**MANDATORY SERVICE BULLETIN NO. MSB 40-096 REV. 0**

Model: DA 40-180

Installation of a limitation placard for the GFC 700 autopilot.

Figure 2. Location of the GFC 700 autopilot limitation placard.

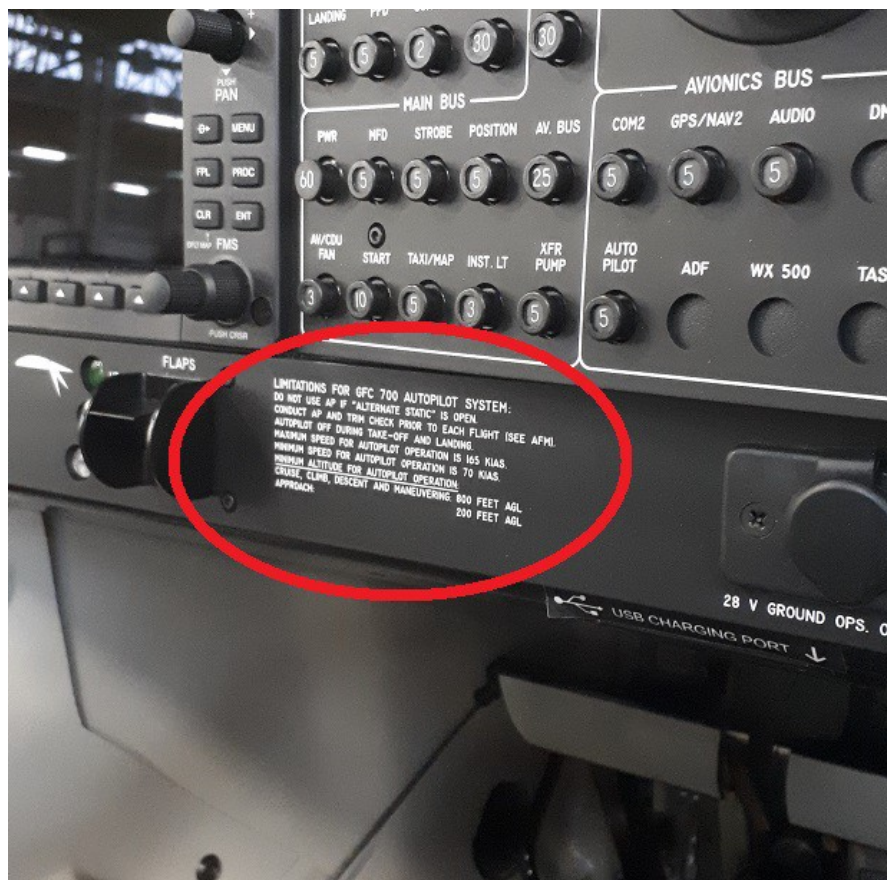
2. If there is no placard specifying the limitations of the GFC 700 autopilot, install item 1 under the circuit breakers as shown in Figure 2. Clean the area with isopropyl alcohol prior to installing the placard. The area must be free of contamination. Take care when positioning the placard. Attempting to reposition the placard may damage it.
